**The Scottish Government  
Energy Consents Unit**

**Scoping Opinion on behalf of Scottish Ministers under the  
Electricity Works (Environmental Impact Assessment) (Scotland)  
Regulations 2017**

**Spittal - Loch Buidhe - Beaully 400 kV OHL Connection**

**5 February 2025**

Figure 2.1 (Appendix A of the EIA Scoping Report) Showing the extent of the connection route

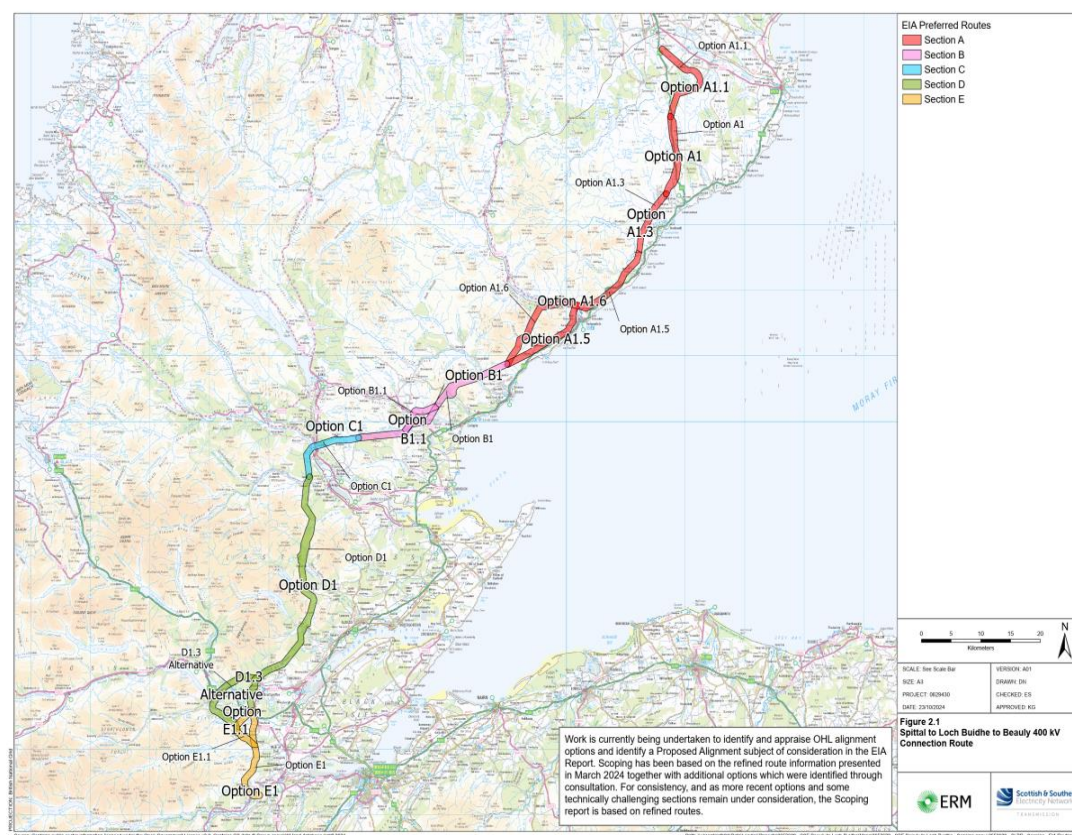
### 3. Requirement to include the access tracks within the Transport Assessment

#### i) Scope of Impact on the local road network

Overview Plan showing the extent of detailed access information sheets for Section A

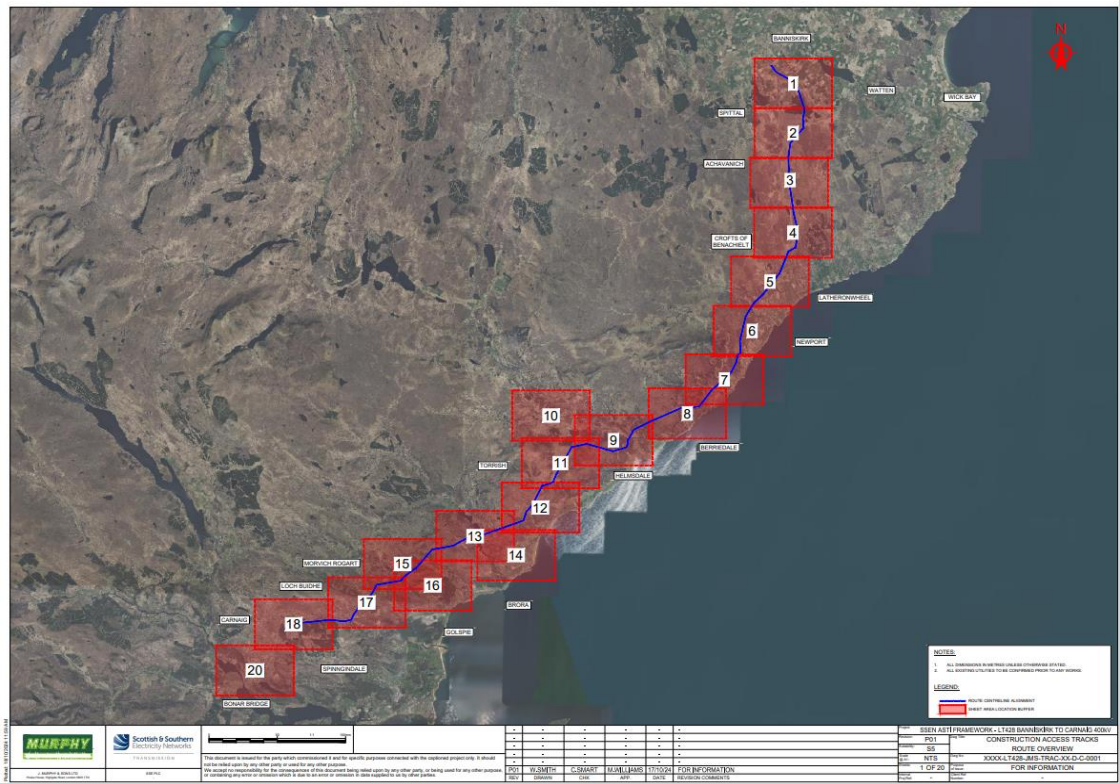
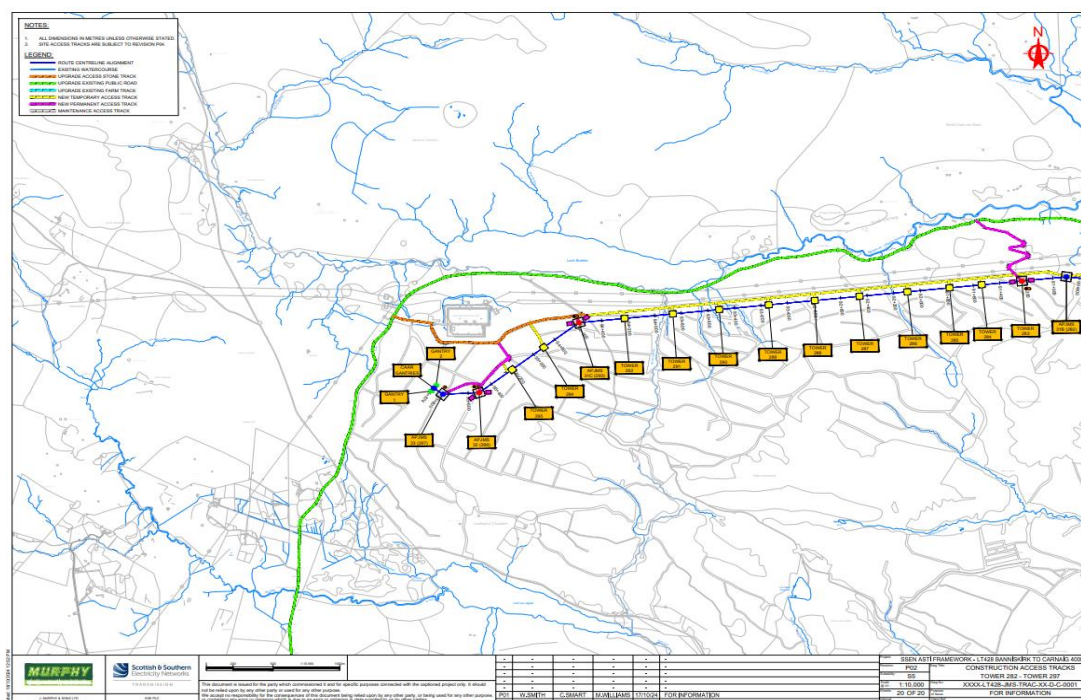
Example Plan showing extent of access tracks and impact on local road: Sheet 20 of 20 for Section A.

Extract from the Agreed Route Map for Timber Transport. For all routes except those shown green consultation is required with the road's authority for standard HGV movements. [Link to website](#):

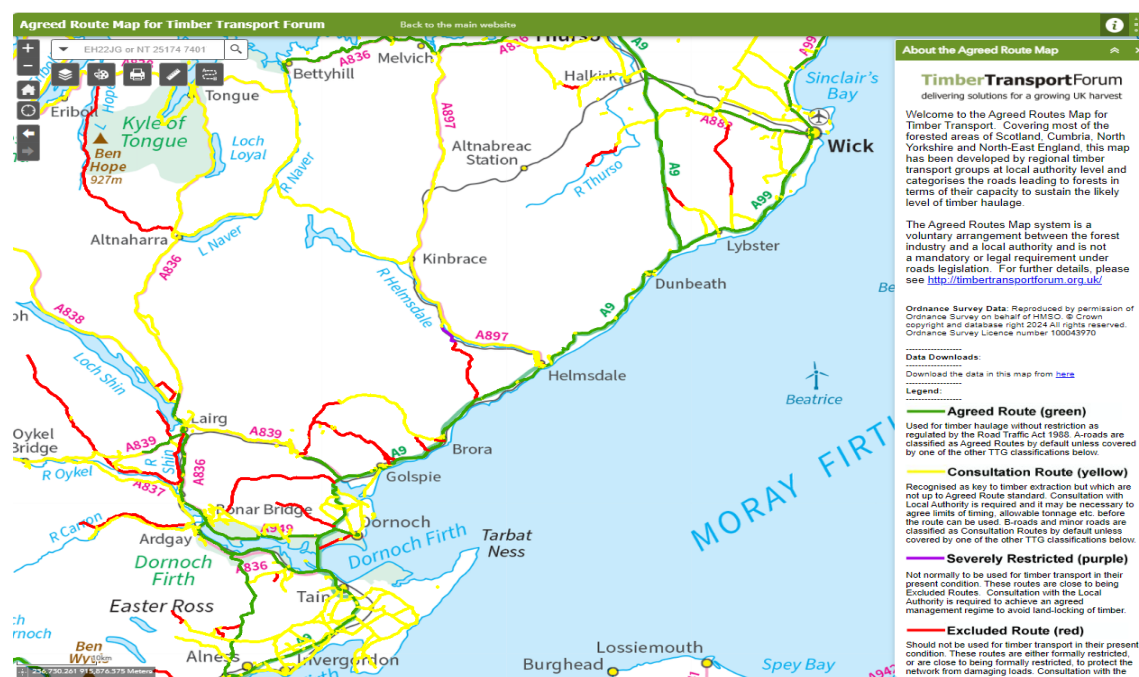
## ii) Significance of Impact on the local road network – fragile local road network
